Improving the extinction ratio specs

Piers Dawe

Mellanox

Table 139-14 for 50GBASE-FR or 50GBASE-LR (to align with Table 122-19, for 200GBASE-FR4, 200GBASE-LR4, 400GBASE-FR8, and 400GBASE-LR8)

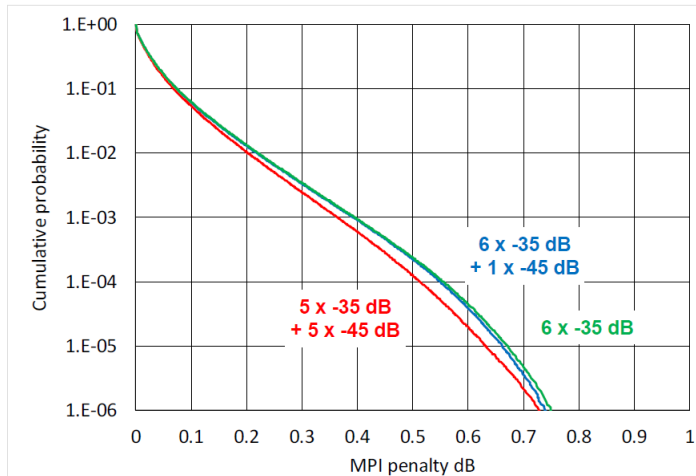
Consequential changes to reflections in cable plant, Clause 139 – FR, LR 2 of 2

Number of discrete reflectances above –55 dB	Maximum value for each discrete reflectance	
	50GBASE-FR (as 200GBASE-FR4 or 400GBASE-FR8)	50GBASE-LR (as 200GBASE-LR4 or 400GBASE-LR8)
1	–25 dB	–22 dB
2	–31 dB	–29 dB
4	–35 dB	–33 dB
6	–38 dB	–35 dB
8	–39 <u>–40</u> dB	–37 dB
10	–40 <u>–41</u> dB	–38 <u>–39</u> dB

Table 140–6—100GBASE-DR transmit characteristics

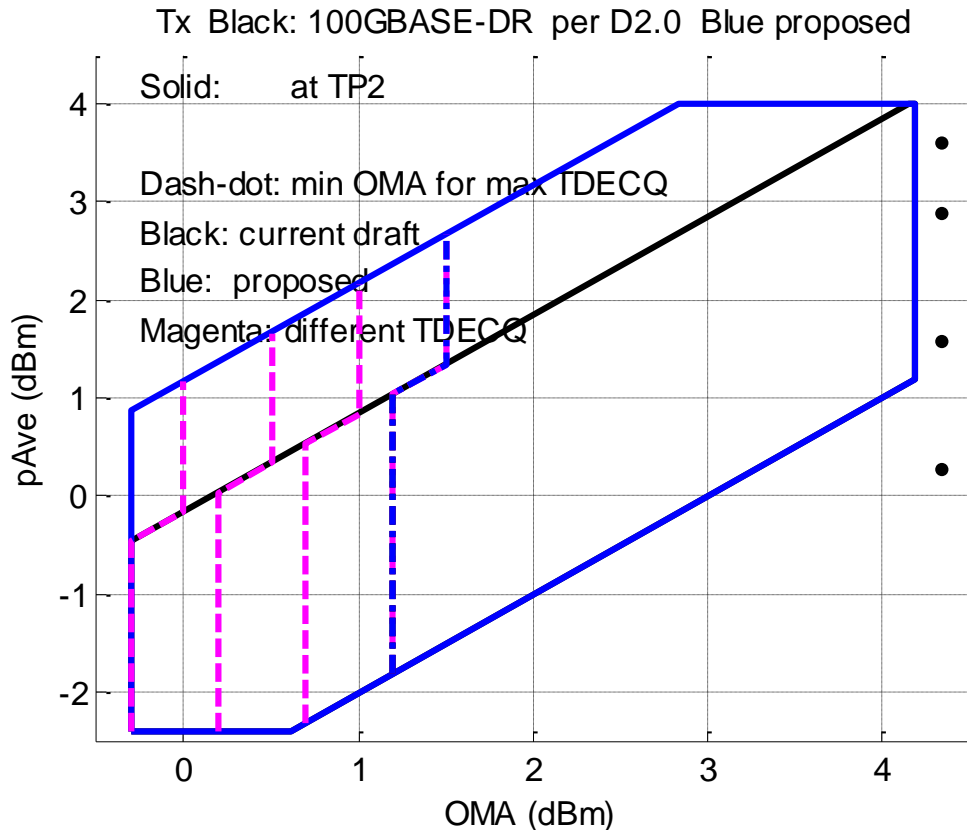
This the proposal in comment 44

Is it worth modifying the OMA min?

Outer Optical Modulation Amplitude (OMA _{outer}) (min) ^b		dBm
<u>for extinction ratio ≥ 5 dB</u>	–0.3	dBm
<u>for extinction ratio < 5 dB</u>	<u>0</u>	<u>dBm</u>
Launch power in OMA _{outer} minus TDECQ (min)		
<u>for extinction ratio ≥ 5 dB</u>	–1.3	dBm
<u>for extinction ratio < 5 dB</u>	<u>–1</u>	<u>dBm</u>
